Letter submitted by Brigit S. Barnes & Associates, Inc. dated November 6,
2018 opposing the project

Re: Recycling Industries Transfer Station; Use Permit Revisions
Draft Subsequent Initial Study/Mitigated Negative Declaration ("MND")
State Clearinghouse (SCH) #2014052082
COMMENTS ON MITIGATED NEGATIVE DECLARATION
Reservation of Rights regarding Comments on City's Peer Review

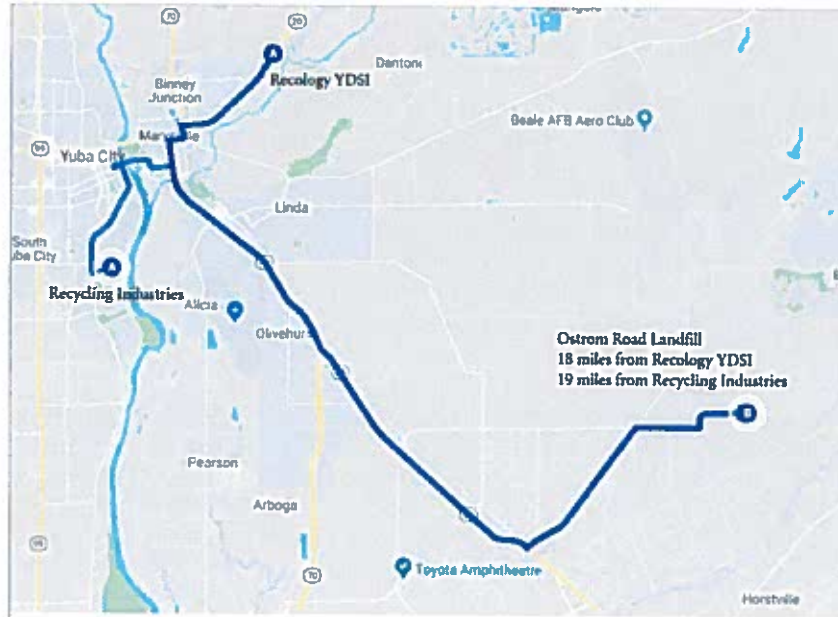
Third, the 2018 MND does not consider whether trip lengths by transfer trucks delivering waste from the facility to a landfill compared to existing conditions. For example, trip lengths by transfer trucks traveling between the Recycling Industries facility and the Ostrom Road landfill would be longer than trips lengths from transfer trucks traveling between the Recology YSDI transfer facility and the Ostrom Road landfill. Each transfer truck makes a two-way trip to and from the facility. These are not the same trucks that

deliver source material to the transfer station in the first instance. Below is a map that illustrating the longer distance transfer trucks will have to travel from the Recycling Industries Transfer Station to the Ostrom Road Landfill.

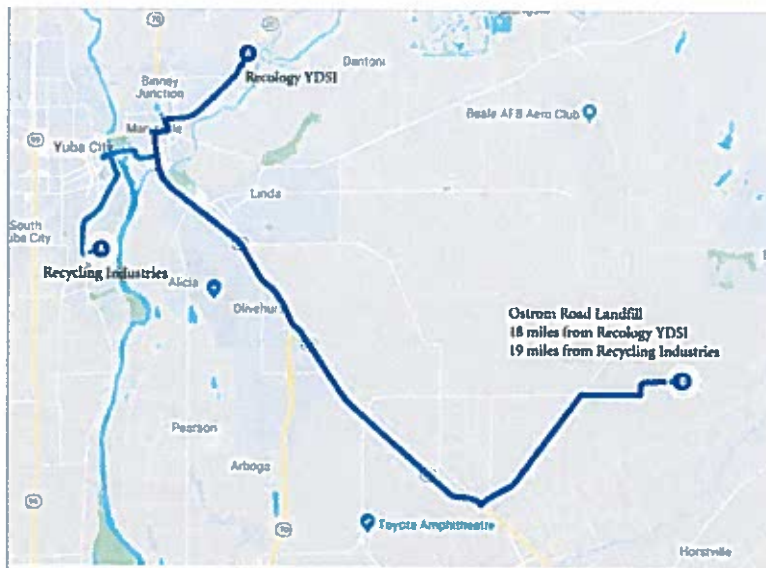
Third, the 2018 MND does not consider whether trip lengths by transfer trucks delivering waste from the facility to a landfill compared to existing conditions. For example, trip lengths by transfer trucks traveling between the Recycling Industries facility and the Ostrom Road landfill would be longer than trips lengths from transfer trucks traveling between the Recology YSDI transfer facility and the Ostrom Road landfill. Each transfer truck makes a two-way trip to and from the facility. These are not the same trucks that deliver source material to the transfer station in the first instance. Below is a map that illustrating the longer distance transfer trucks will have to travel from the Recycling Industries Transfer Station to the Ostrom Road Landfill.
